UNITED STATES PATENT AND TRADEMARK OFFICE

APPLICATION NO.	FILING DATE	FIRST NAMED INVENTOR	ATTORNEY DOCKET NO.	CONFIRMATION NO.
10/541,281	02/03/2006	Gerrit Jan Nieuwenhuis	MULLE45.001APC	6247
20995 7590 07/11/2007 KNOBBE MARTENS OLSON & BEAR LLP 2040 MAIN STREET FOURTEENTH FLOOR IRVINE, CA 92614			EXAMINER BUI, LUAN KIM	
			ART UNIT 3728	PAPER NUMBER
			NOTIFICATION DATE 07/11/2007	DELIVERY MODE ELECTRONIC

Office Action Summary

FOIL BAG PROVIDED WITH A PUNCHED OPENING AND
INCISIONS

FIG. 1

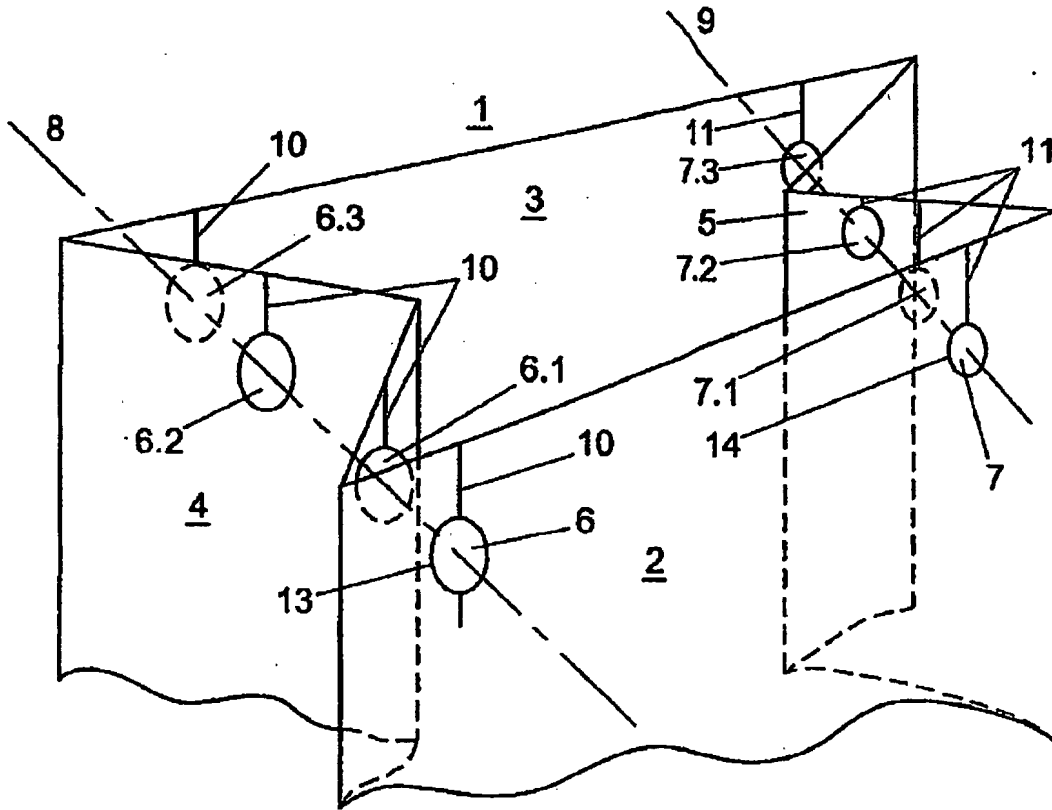
1. The proposed drawing correction and/or the proposed substitute sheets of drawings, filed on 5/21/2007 have been disapproved for entry because drawings introduce new matter. 37 CFR 1.2121 (f) states that no amendment may introduce new matter into the disclosure of an application. The original disclosure does not support the showing of the added features in Figure 1 because the original disclosure states “an incision line 10, 11, 20, 21 may extend e.g. straight from the upper edge of the foil bag to the upper circumferential edge of the opening and then moreover may extend over a length of some millimeters to about 2 centimetres beyond the lower circumferential edge of the opening” but does not indicate that only one of the incision lines may extend beyond the lower circumferential edge of the opening as shown by the Applicant of the incision line 10 in Figure 1. Correction is required.

NOT APPROVED FOR ENTRY. L.R. Bu)
6/25/07

Corrected drawing sheets in compliance with 37 CFR 1.121(d) are required in reply to the Office action to avoid abandonment of the application. Any amended replacement drawing sheet should include all of the figures appearing on the immediate prior version of the sheet, even if only one figure is being amended. The figure or figure number of an amended drawing should not be labeled as “amended.” If a drawing figure is to be canceled, the appropriate figure must be removed from the replacement sheet, and where necessary, the remaining figures must be renumbered and appropriate changes made to the brief description of the several views of the drawings for consistency. Additional replacement sheets may be necessary to show the renumbering of the remaining figures. Each drawing sheet submitted after the filing date of an application must be labeled in the top margin as either “Replacement Sheet” or “New Sheet” pursuant to 37 CFR 1.121(d). If the changes are not accepted by the examiner, the applicant will
